Packard

55T-10

February 10, 1955

Subject: WINDSHIELD WEATHERSTRIP AND MOULDING RETAINERS - 55TH SERIES

432183 RETAINER

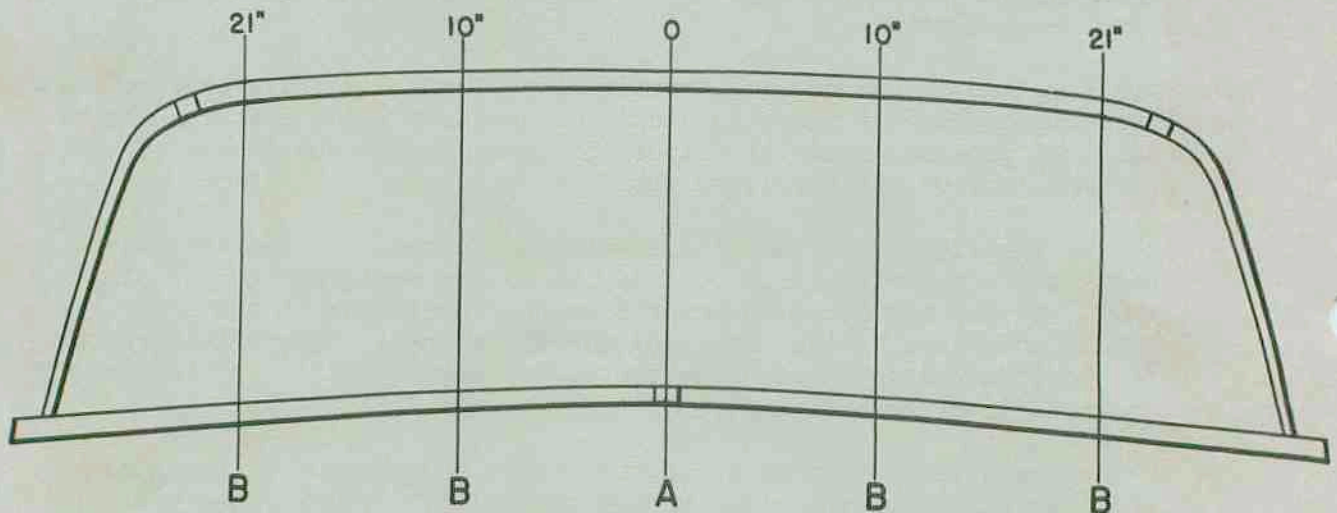
The windshield glass in a few early production 55th Series cars has a tendency to work forward at the lower edge permitting the upper edge of the glass to drop out of the weatherstrip.

This condition can be corrected in the field by installing five retainers along the forward lower edge of the windshield weatherstrip which stiffens the weatherstrip and also provides a better fit of the lower chrome mouldings. To install the retainers, follow the procedure outlined:

- c. Cut $3/16$ " from the ends of four of the retainers as shown. Drill four $7/64$ " holes at locations B through the weatherstrip and body flange at the angle shown in Section "B" of the illustration. Place some dum-dum over the holes and install the four retainers with screws at locations B.

- d. Drill a $3/32$ " hole in the bead on the body flange at location A, exactly centered between the ends of the chrome mouldings and at the angle shown in Section "A". Place some dum-dum over the hole. Using a small punch in the hole of the retainer that was not cut off, bend it slightly so that the screw can be installed almost vertically.

CUT HERE - 4 PIECES
FOR USE AT 10" & 21"
(B) STATIONS
